SYDNEY CENTRAL CITY PLANNING PANEL

COUNCIL ASSESSMENT REPORT

Panel Reference	PPSSCC-316
DA Number	DA/1100/2021
LGA	City of Parramatta Council
Proposed Development	Melrose Park North street network (roads, footways, street trees, landscaping, drainage, services, and associated infrastructure); including tree removal, remediation and bulk earthworks; and Torrens subdivision.
Street Address	38-42 Wharf Road, 82-84 Wharf Road, 33 Hope Street MELROSE PARK NSW 2114 and 27-29 Hughes Avenue ERMINGTON NSW 2115 (Lot 10 DP 1102001, Lot 11 & 12 DP 787611, Lot 6 DP 232929, Lot 200 & 201 DP 1265603, Lot 1 DP 213196)
Applicant	Sekisui House
Owner	SH Melrose PP Land Pty Ltd Deicorp Projects (MPTC) Pty Ltd
Date of DA lodgement	Original: 6 December 2021 Revised Drawings: 17 February 2023
Number of Submissions	Multiple submissions from eleven (11) households/businesses.
Recommendation	Approval subject to conditions
Regional Development Criteria	Clause 2 'General development over \$30 million' of Schedule 6, State Environmental Planning Policy (Planning Systems) 2021

Report date	4 December 2023

Figure 10. EWR-3 / Wharf Road Interface. Original proposal – EWR-3 connecting to Wharf Road – on left (resulted in loss of 10 category A/AA trees). Revised proposal – cul-de-sac of EWR-3 short of Wharf Road – on right (results in loss of only 3 A trees)

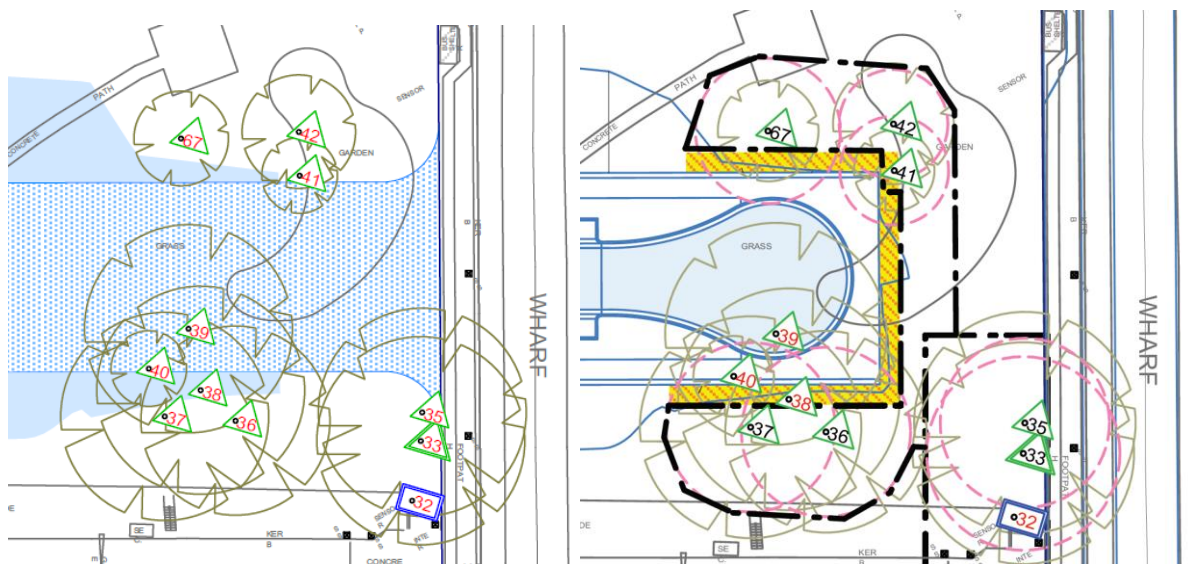
- Revise eastern extent of EWR-3 to end in cul-de-sac and delete connection to Wharf Road, to reduce loss of trees, reduce total road hardstand, increase connectivity in Wharf Road Gardens open space, reduce traffic in Wharf Road.

Figure 11. Retaining walls RW01 and RW02 (left) and RW03 and RW05 (right).

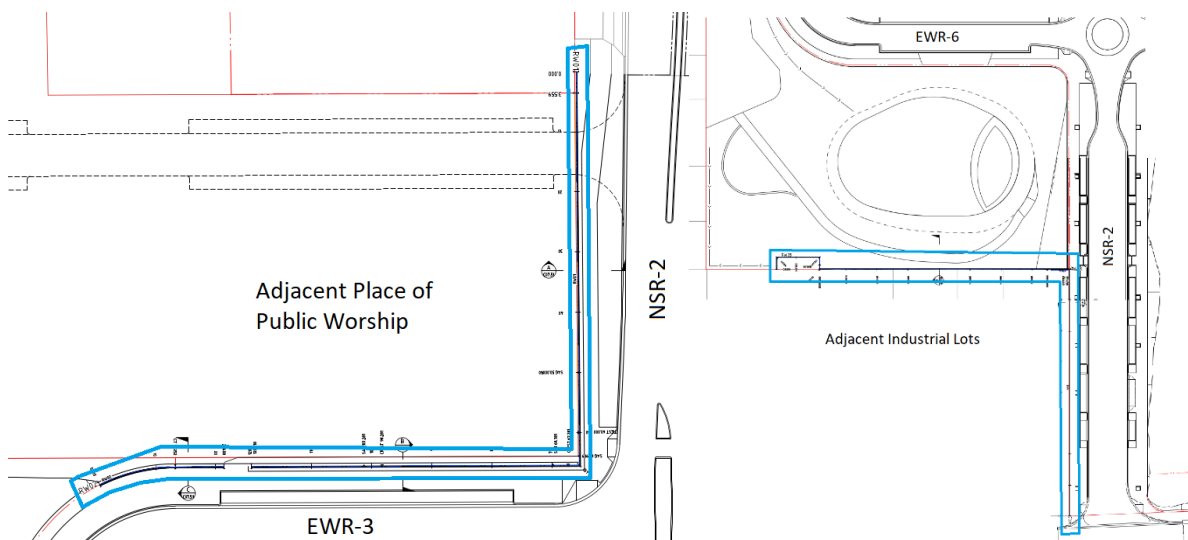
8.2.6.2.18 Retaining Walls	<p>The proposal includes 4 retaining walls, all of which are on or near boundaries of the site the opposite side of which is likely to be redeveloped (see Figure 10 below). It is likely that redevelopment of those adjacent sites will be able to include regrading to match the proposed levels, thus burying/demolishing the retaining walls and making them redundant. The retaining walls in the interim should not have an unacceptable impact on the amenity of the adjoining sites as the adjacent uses are either industrial or the walls are far removed from the primary use of the site.</p> <p>As the retaining walls are not intended to be permanent features of the landscape, it is not considered necessary for them to be designed for aesthetics or ancillary functionality. However, given they will partly support/protect land to be dedicated to Council, Council will need to sign off on their detailed design. Conditions are included to this effect.</p> <p>The western extent of retaining wall RW03 deviates into the site. In order to ensure that it can be 'buried' by future development a condition is included requiring this section be aligned to the southern boundary.</p>	Yes, subject to conditions
